**MUNICIPAL SERVICES CENTER, COUNCIL CHAMBER
3600 TREMONT ROAD**

BZAP Meeting Date: May 3, 2023

Subject: 2231 Inchcliff Drive (VAR-17-23) - To allow a two-story addition encroach up to five feet into the 10-foot minimum rear yard setback and up to 7'-5" into the rear yard profile limit.

BZAP Staff Report Pictures

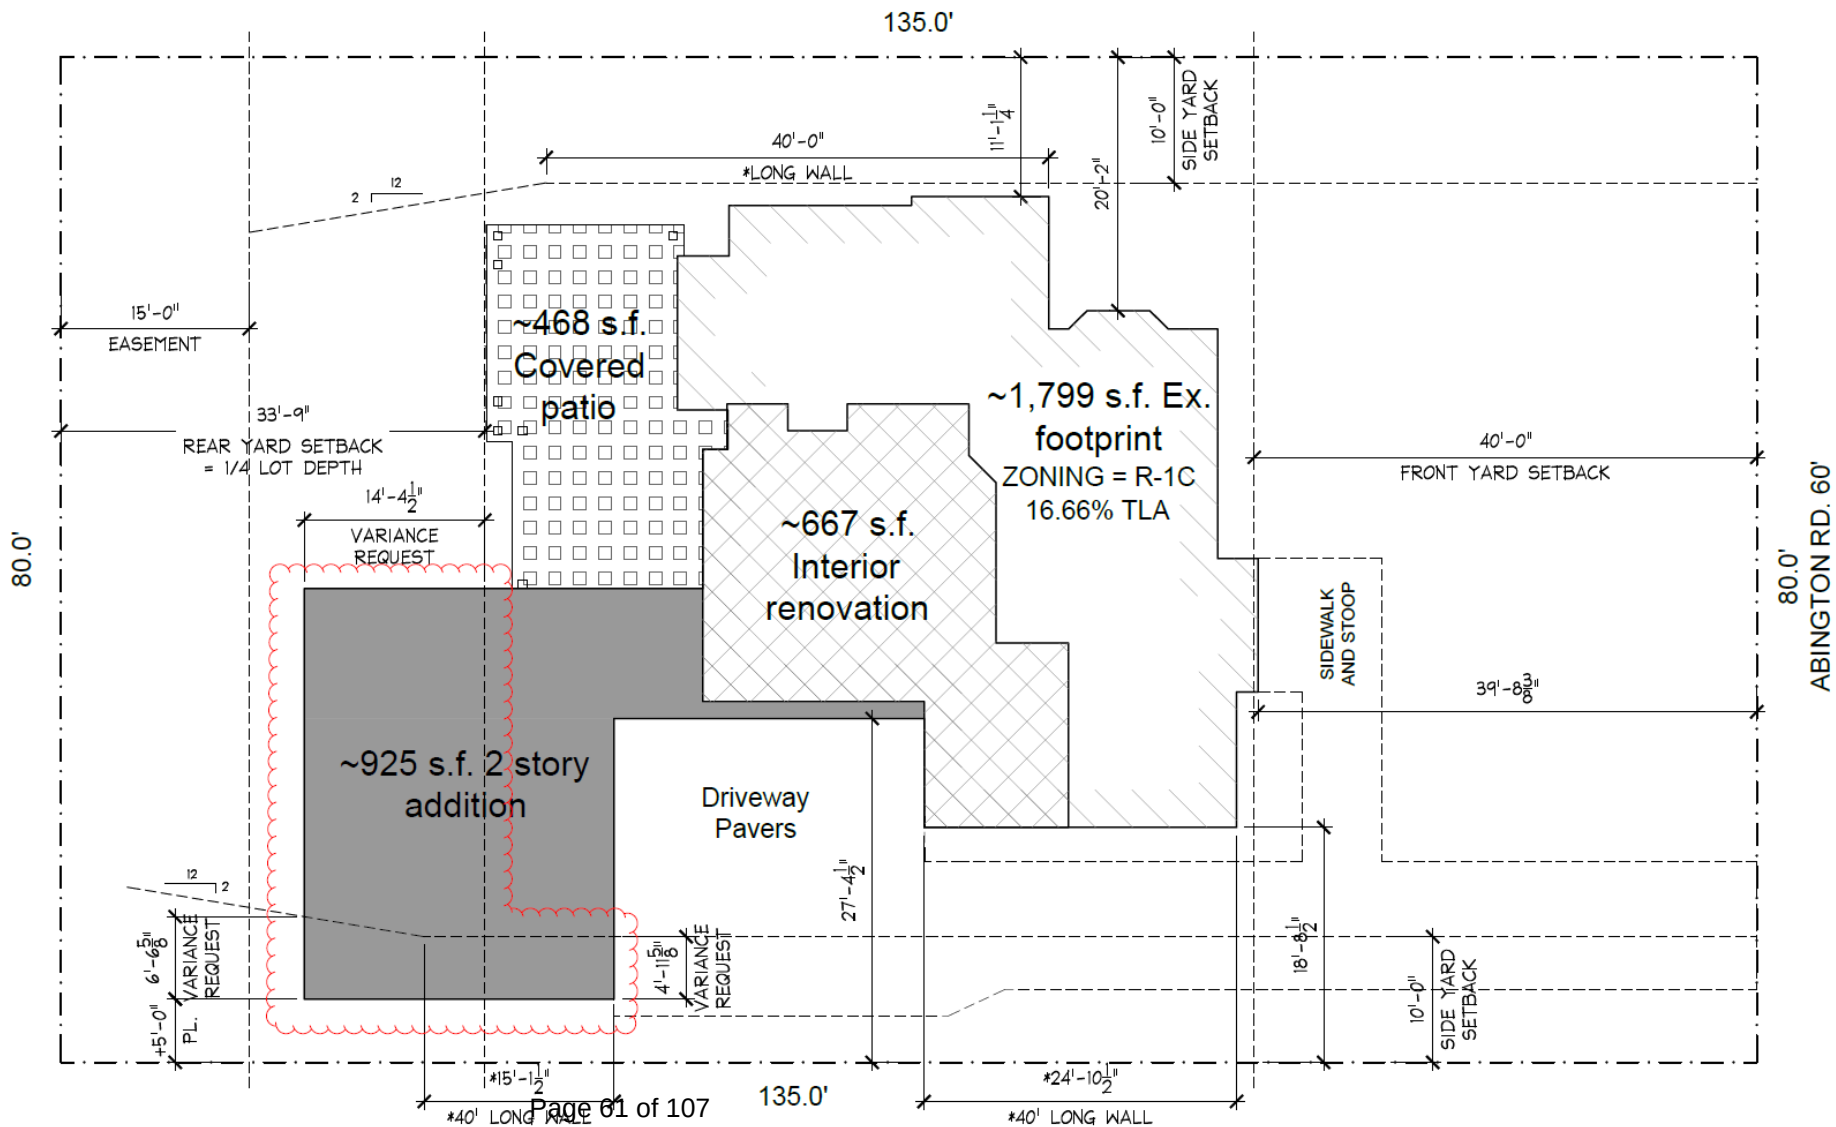
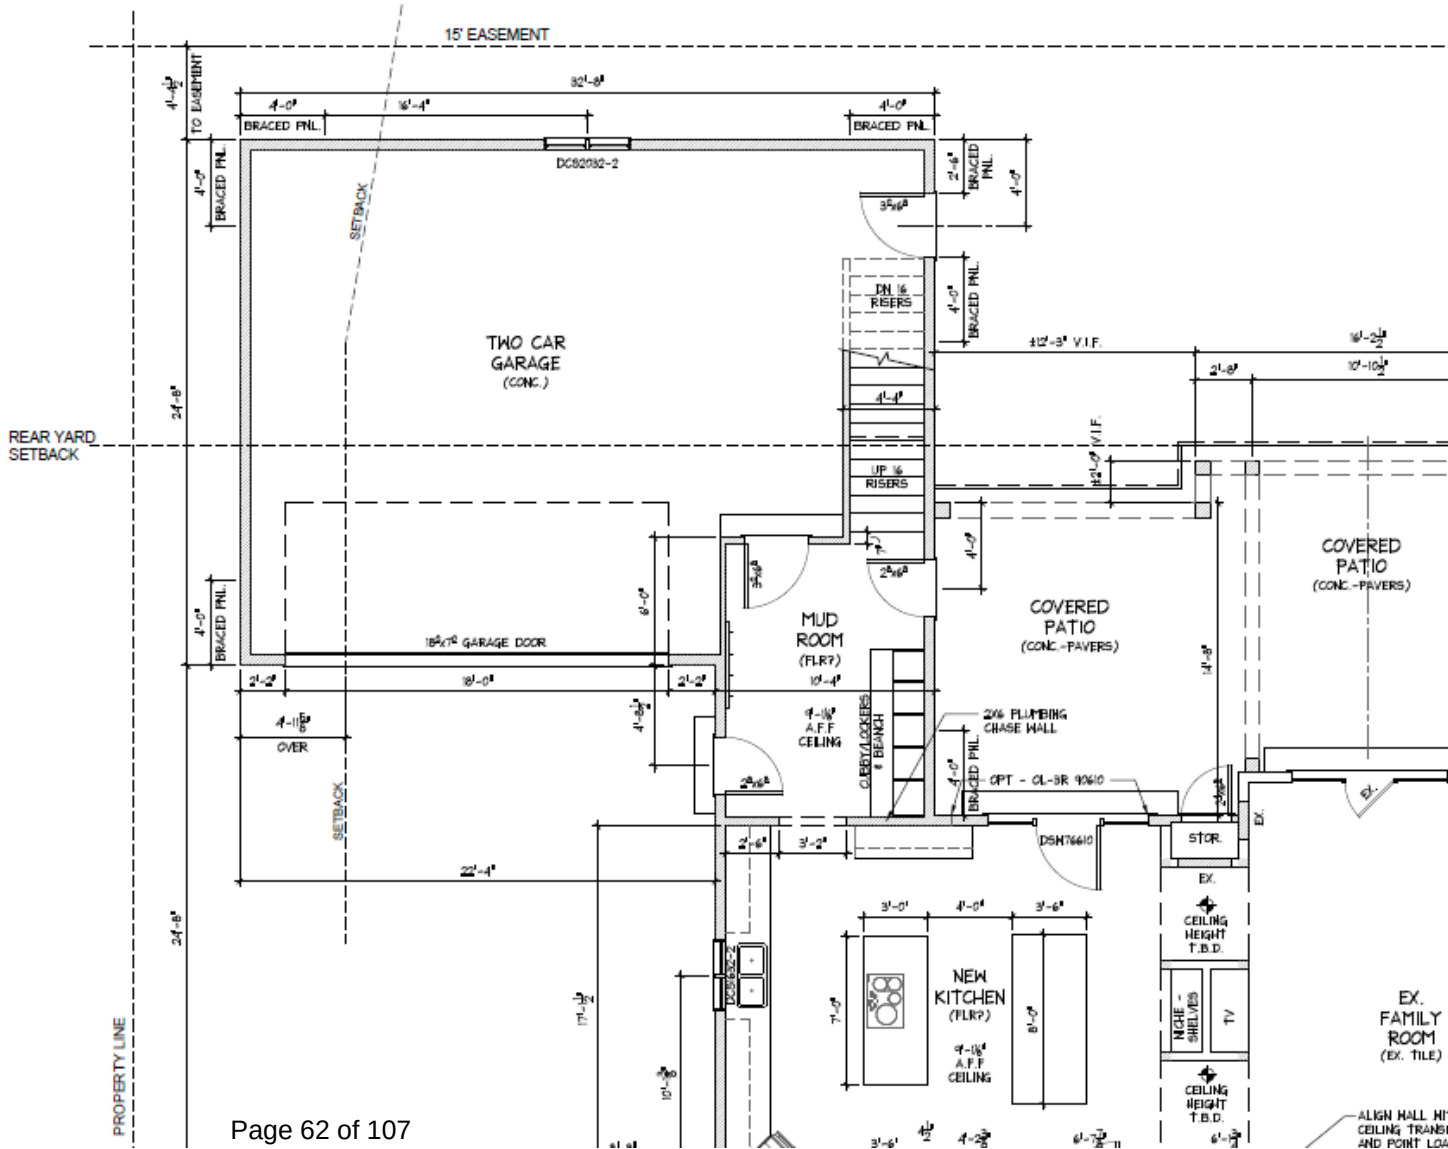
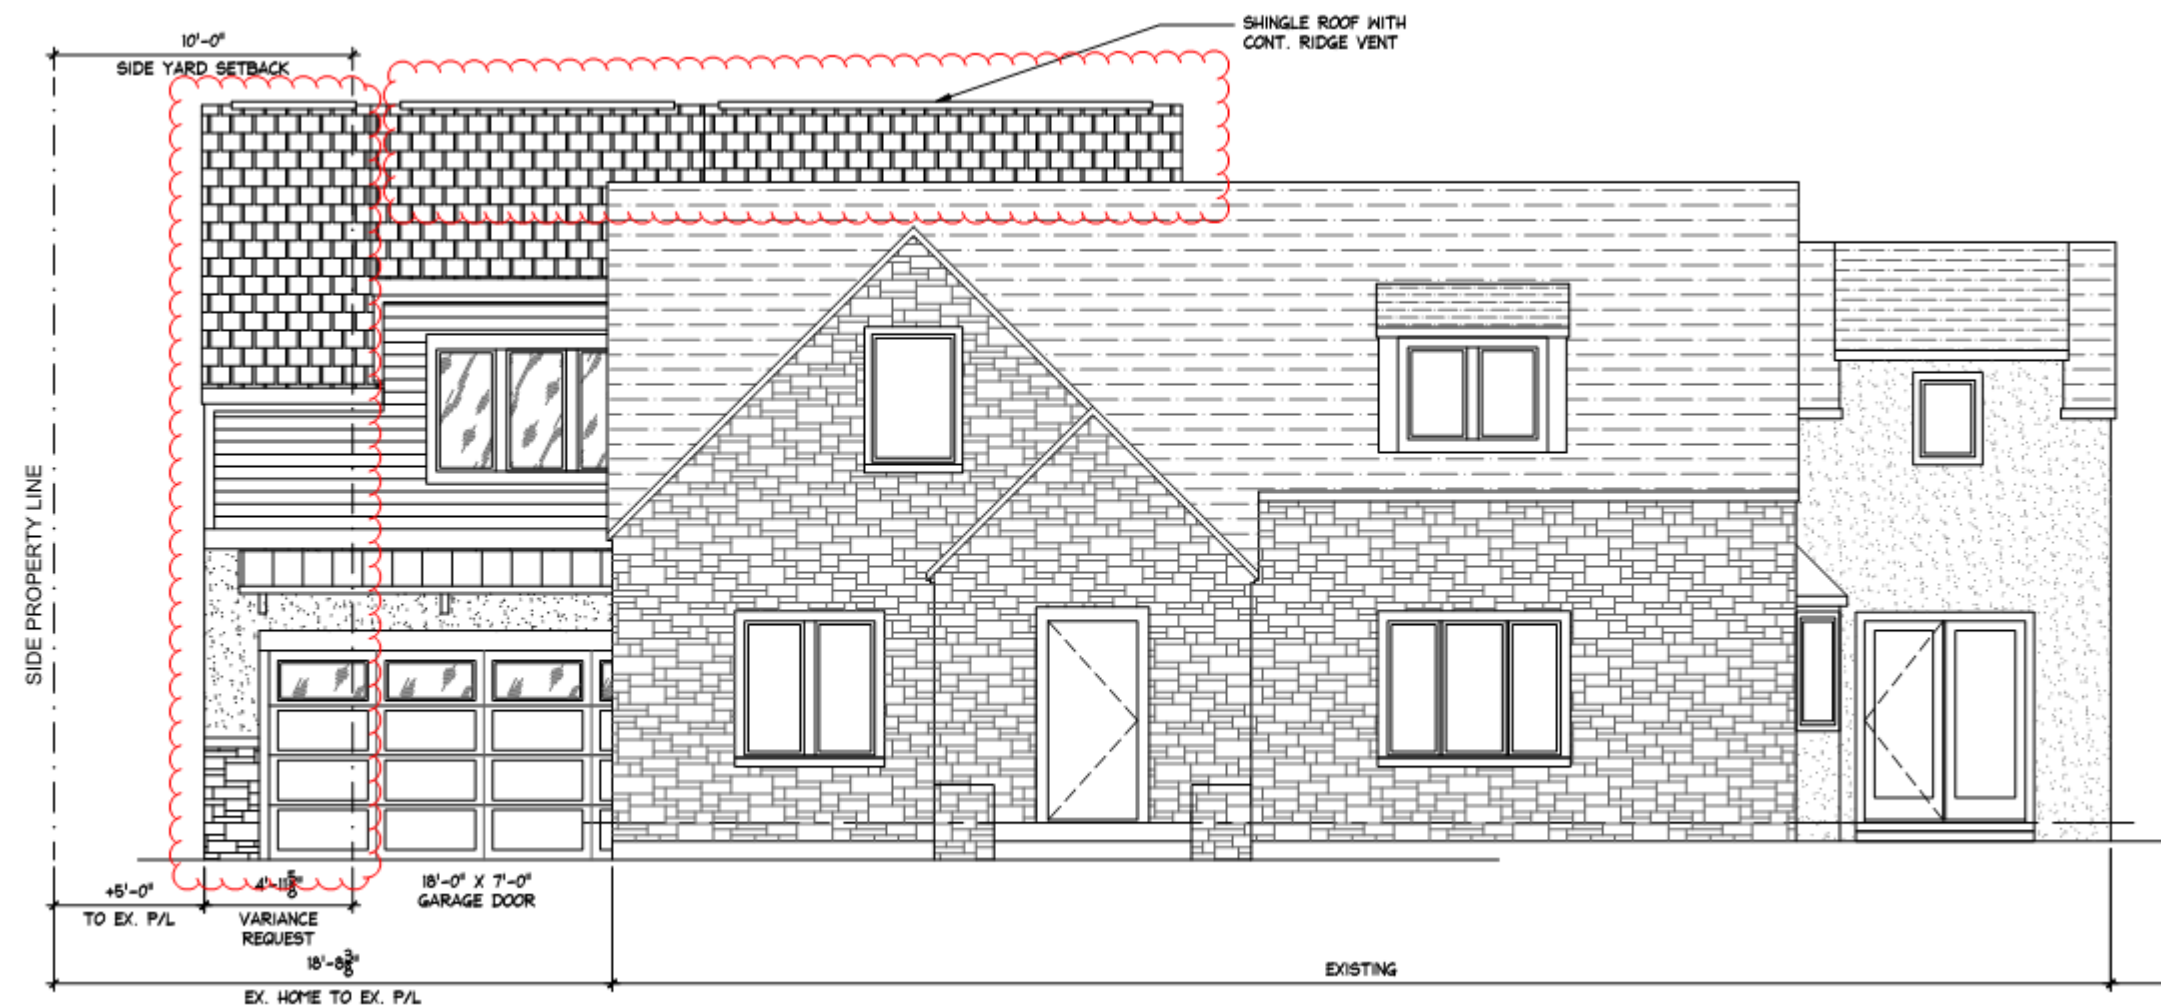
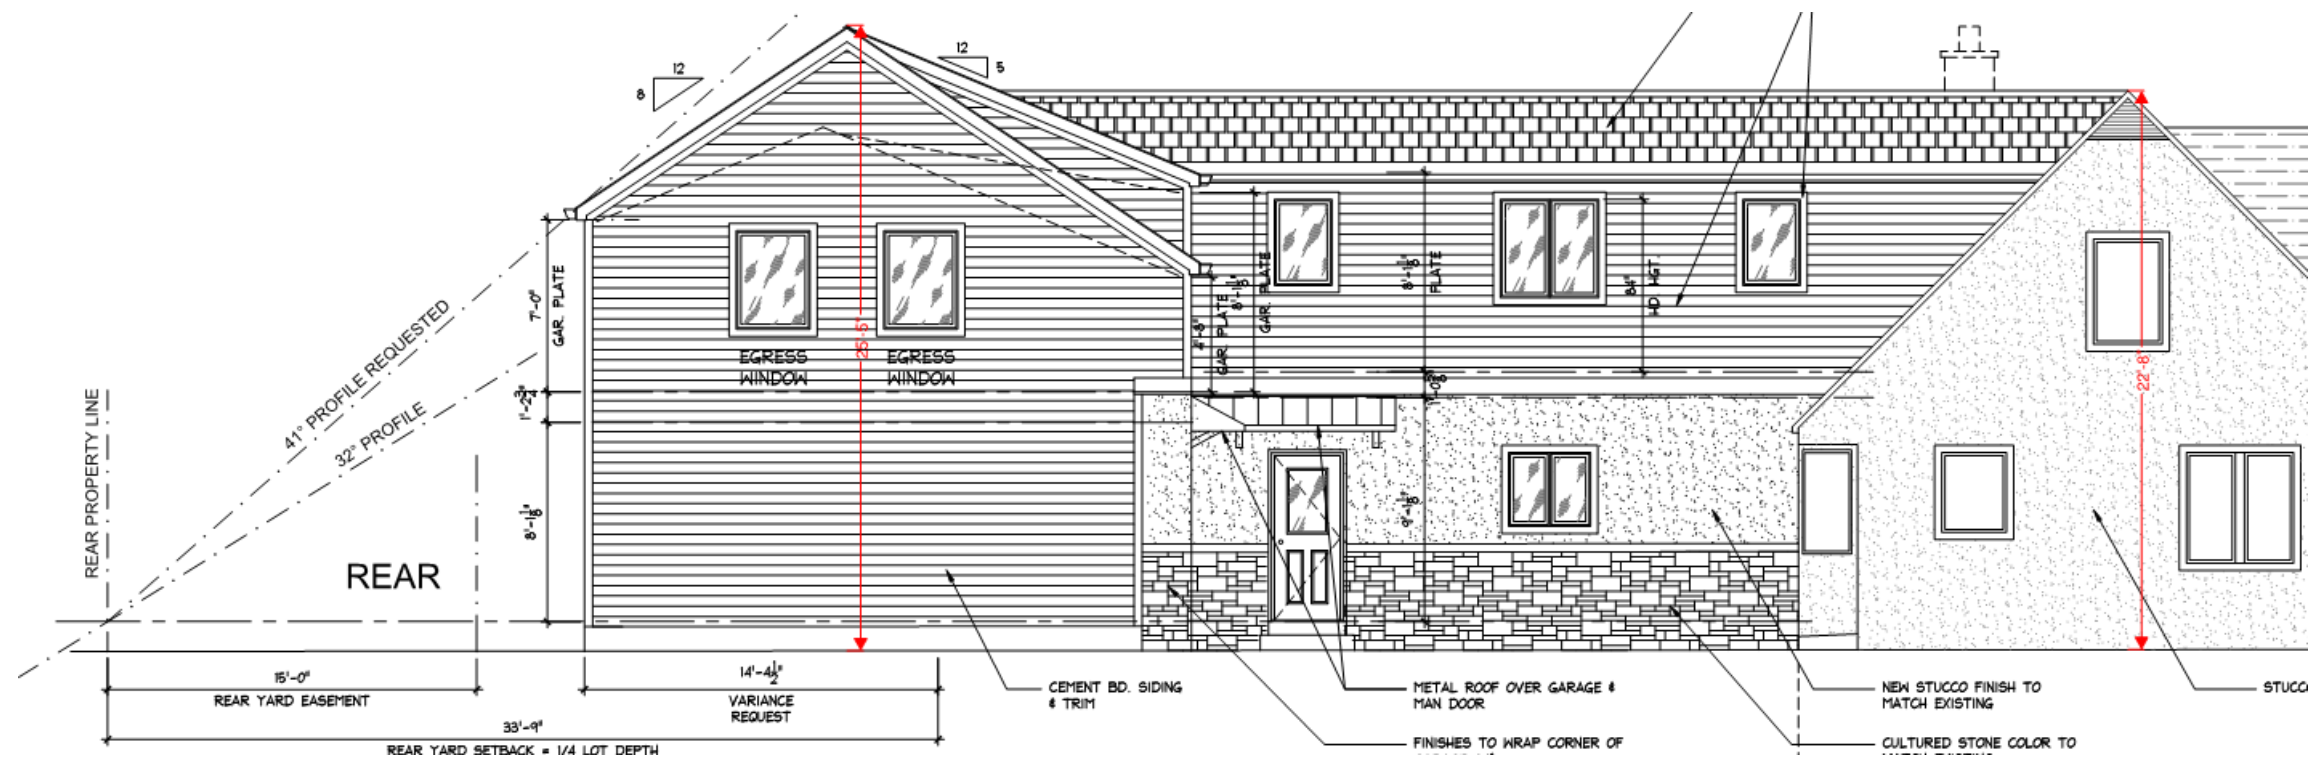
Therefore, Staff cannot recommend approval of the application as submitted. Staff would recommend postponing the case to a Work Session, where the Board may be able to review

alternative designs and provide additional feedback to the applicant. The Board may consider Findings #3 and #4 during deliberations.
